Technical Service Bulletin

MODEL(S) AFFECTED: T7 AMR Autonomous Rider Scrubber equipped with Operating System 2.8 - 2.10

SUBJECT: Safety concern - Potential pinch point hazard regarding the automated squeegee lift system when operating machine in manual mode.

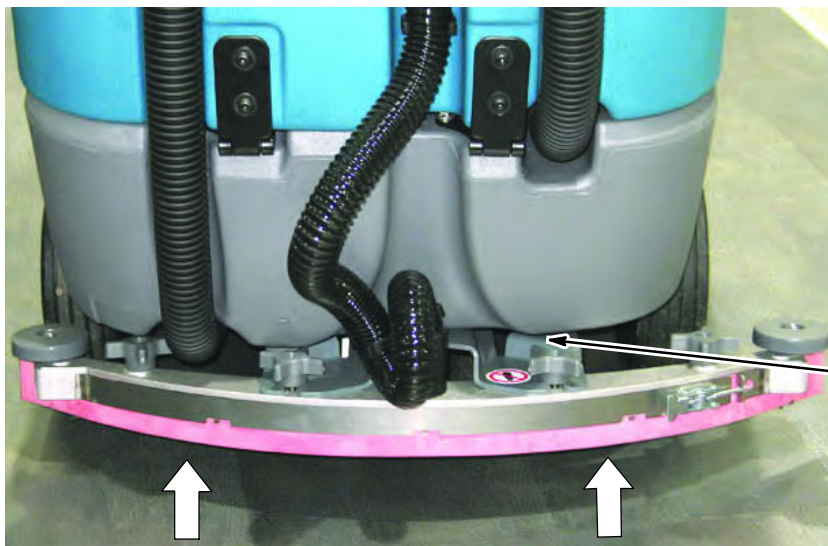
PURPOSE: Squeegee lift system behavior - When operator leaves the seat, the squeegee lift system is triggered to automatically raise off the floor. However, the activation has a 25 second delay before the squeegee lift system is raised. There is a risk of a potential pinch hazard if the operator interacts with the squeegee system during this time span.

Squeegee Lift System - When operator leaves the seat during manual mode there is a 25 second delay before squeegee begins to lift.

Potential Pinch Point Hazard

FOR SAFETY: To prevent a potential pinch point hazard, it is advised to wait until the squeegee lift system is in the raised position before interacting with squeegee system.

NOTES: Subsequent OS software releases will remove the automated squeegee system lift in both autonomous and manual mode.
